Enclosure 2
Westinghouse APP-GW-GLR-607, Revision 4
(NON-PROPRIETARY VERSION)

Changes to Passive Core Cooling System Condensate Return

January 2016

Figure 8: Personnel Airlock Gutter Modification Schematic

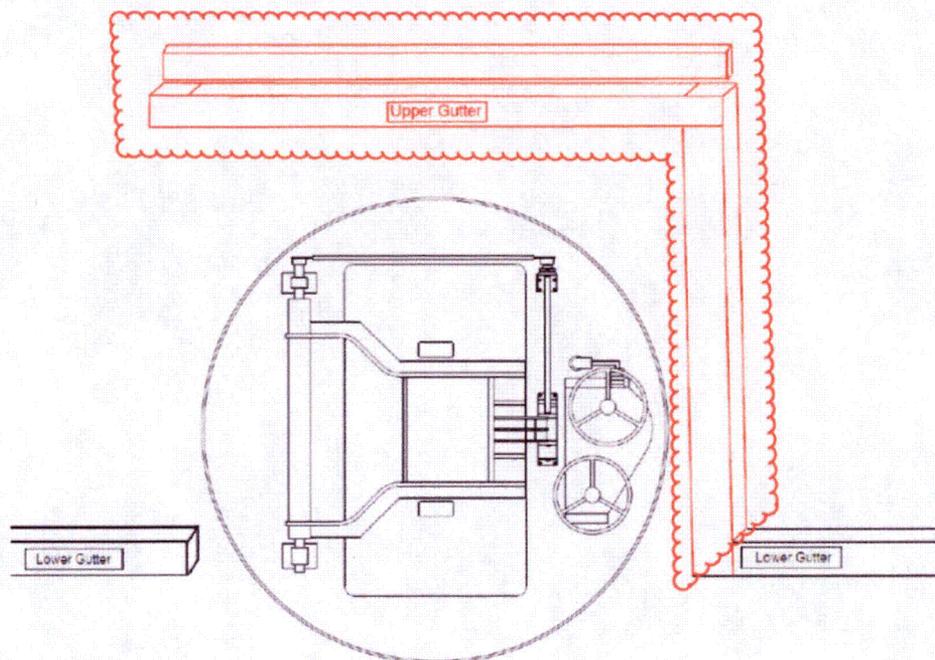
The original IRWST gutter was routed to the edges of the Upper Personnel Airlock and Upper Equipment hatch. [

(a,c) The IRWST gutter will be modified to have an upper gutter above each of the hatches that connects with the existing gutter. The extended gutter is of the same size as the sections which currently interface with the sides of the hatches. The gutter is sloped the same as the existing portions of the gutter. The extended portion of the gutter above the Upper Personnel Airlock is routed to interface with the lower portion of the gutter. Figure 8 shows a schematic of the proposed modification to the IRWST gutter to above the Upper Personnel Airlock. The Upper Equipment Hatch is similarly treated.

Figure 3.8.2-1 (Sheet 3 of 3)

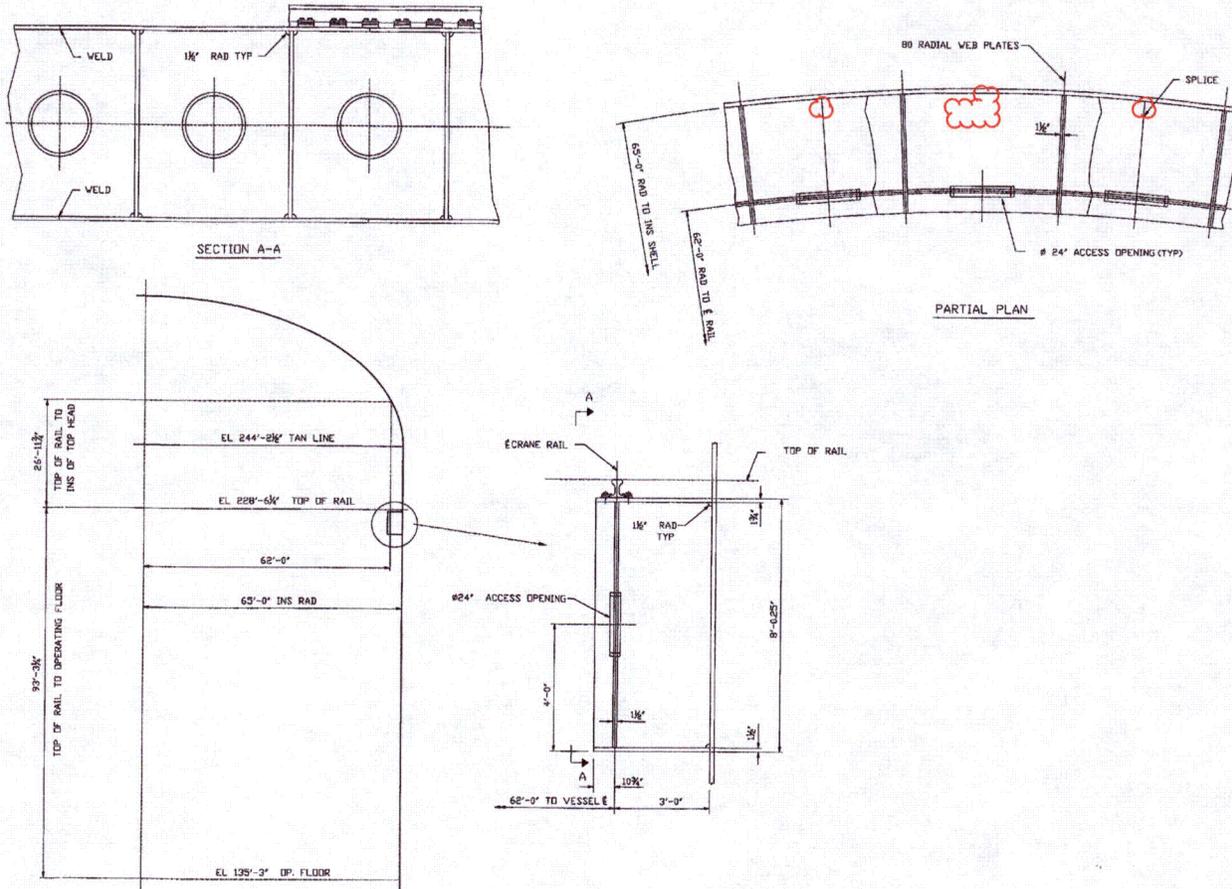
Pictorial detail of the PCG is shown in DCD Chapter 3. Figure 3.8.2-1 (Sheet 3 of 3) shows the fabrication holes in the top right figure. As the fabrication holes in the PCG would be blocked in the modified configuration, this detail will be removed from this figure. The changes are shown in Appendix B.
